CASE STUDY:

Private Office Building; Farmington Hills MI

MEMORANDUM

Re: WATER INFILTRATION
[Redacted] - Farmington Hills, MI

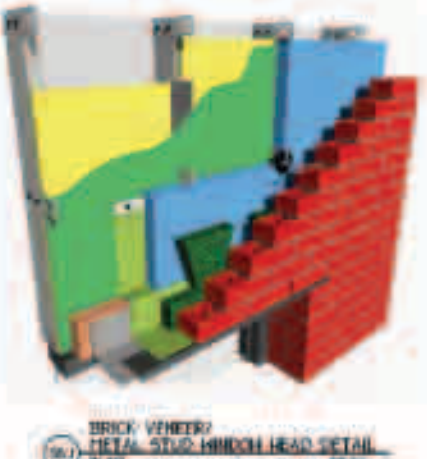
As per our discussion this afternoon, attached, please find documentation with regards to the exploratory work currently underway at [Redacted]. We removed a glazed CMU from the head of the third story windows on the east elevation (suite 300).

Upon removal of the existing glazed CMU course, it was immediately evident that there is some water infiltration. We took note of tar paper in the wall cavity; this paper is of concern as the characteristics of this material allow it to retain moisture. This is troubling considering its location at the "base" of the wall where water is designed to exit the cavity.

The existing flashing is a semi-rigid polyethylene, not typical in modern construction. Current construction practice utilizes a self-adhering, self-sealing product (similar to Air Shield Thru-Wall Flashing by W.R. Meadows). These flashing products are typically 40 mils thick, with cross-laminated polyethylene film. This film has excellent tensile strength and tear-resistance which is beneficial in this application (around the existing bolted connections).

BRICK VENEER/METAL STUD WINDOW HEAD DETAIL
SCALE: N.T.S.

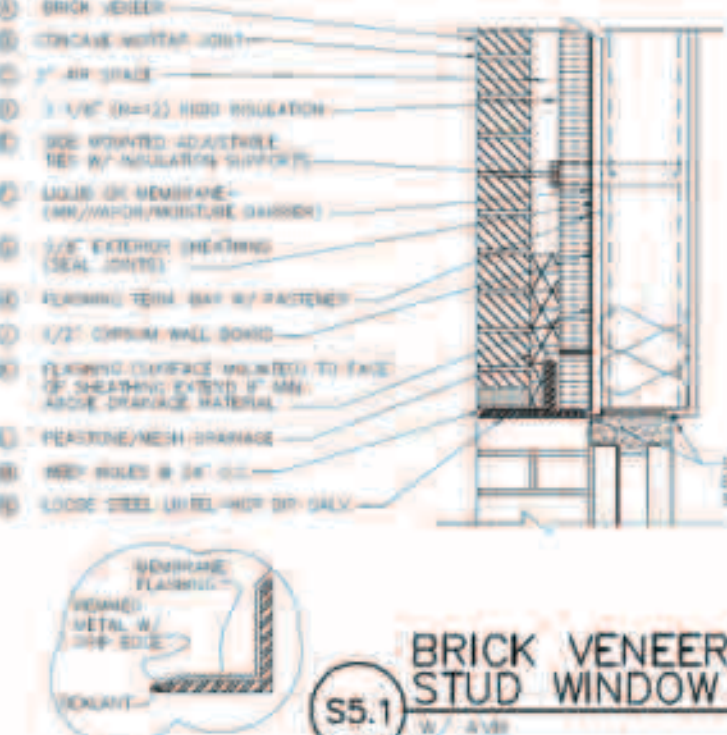
Through our investigation, we have been able to determine that the existing flashing system is failing, causing water infiltration into the building envelope. The proper way to mitigate the infiltration is to update the flashing system to modern construction practices / masonry standards.

We would propose to remove the masonry (approximately 2'4" high) at the existing window head(s), remove the existing flashing system complete and install a new system, similar to the detail(s) provided previously in this report. This would include: (1) self-adhering / self-sealing flashing product; (2) installation of a termination bar with screws & mastic at top of flashing termination (to the back-up sheathing); (3) installation of a tyne-coated drip edge (to match window framing) set in mastic, to allow water to flow over the window away from the building; and the (4) installation of a cell vent / wick weep system to transfer the water from behind the wall cavity through it to the exterior. Cavity/Mesh drainage material would not be required due to the existing masonry in place over head and no mortar "dropping" into the flashing cavity. We would then propose to replace the masonry with new, either glazed CMU to match the existing, or a comparable product. We believe a more cost-effective product would be an integrally colored "red" cast stone product to match the color palette of the existing building. Finally, we would propose a new water application (clear) over the finished work as well as the entire exterior masonry system.
